RE: **Lot 7 Block 4 Unit 19 SAD 228**
65323 Azor Ln. NW
Volcano Cliffs Subdivision
Grading and Drainage Plan
Engineers Stamp Date 5/7/18 (D10D003T7)

Based upon the information provided in your submittal received 5/7/18, this plan is approved for Grading Permit.

ENGINEER'S SEAL	Title 6532 AZOR LANE NE	DRAWN BY
			DATE
		GRADING AND DRAINAGE PLAN	Day
		<i>RHD Engineering, LLC</i> 4305 Purple Sage Ave. NW ALBUQUERQUE, NM 87120 (505) 288-1621	SHEET # 1 of 1 JOB #

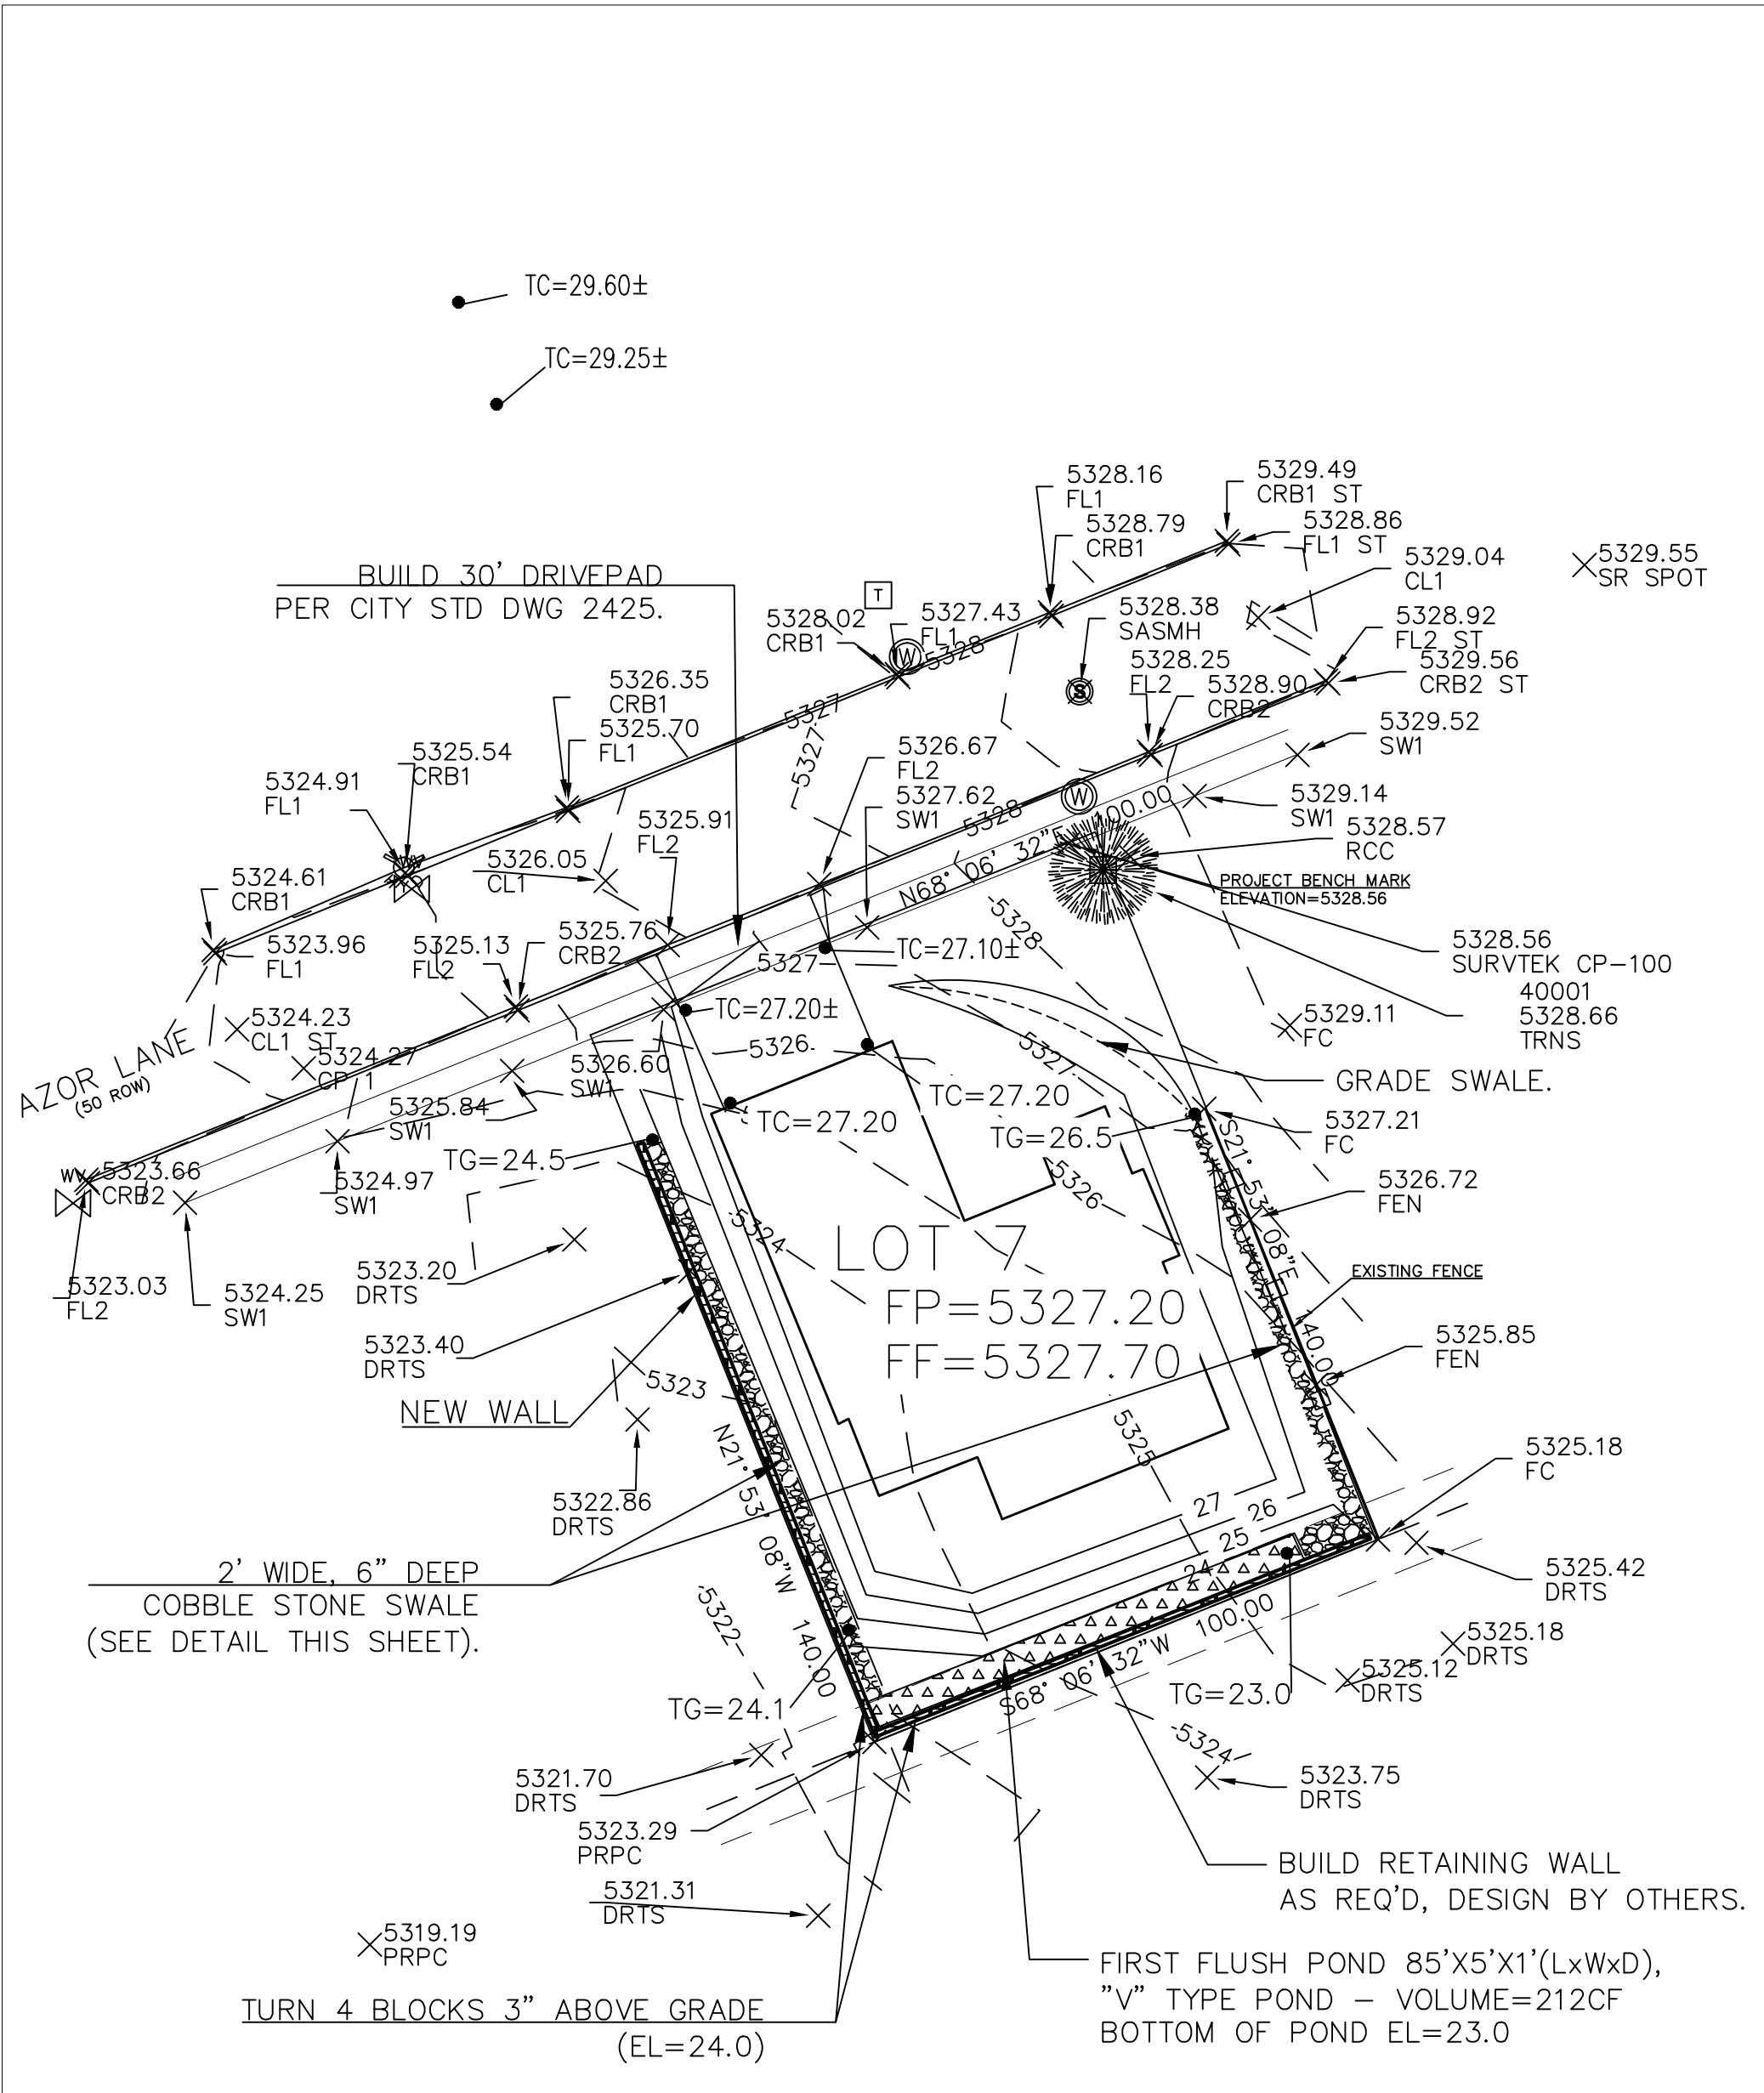
Prior to building permit approval a pad certification will be required.

Prior to Certificate of Occupancy release, Engineer Certification per the DPM checklist of this plan will be required.
